LIMITING CONDITIONS FOR OPERATION AND SURVEILLANCE REQUIREMENTS

ADDITIONAL CHANGES PREVIOUSLY
PROPOSED BY LETTER
Serial No. 2612 Date 11/2/99

Docket Number 50-346
License Number NPF-3
Serial Number 2470
Enclosure 2

Figure 3.1-1 Boric Acid Addition System
Minimum Required Volume as
a Function of Boric Acid
Concentration Required in
Modes 1-4

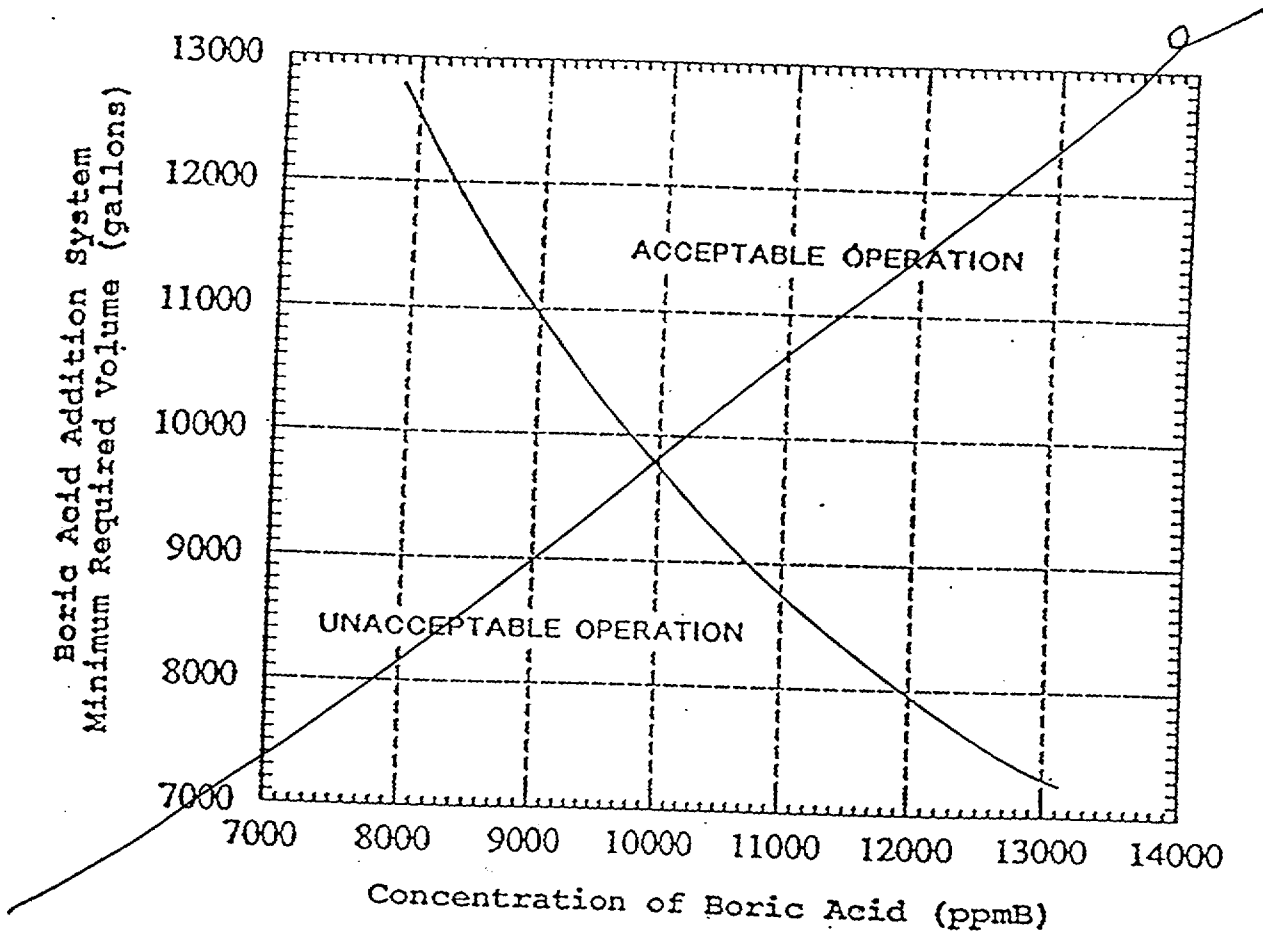
DELETED
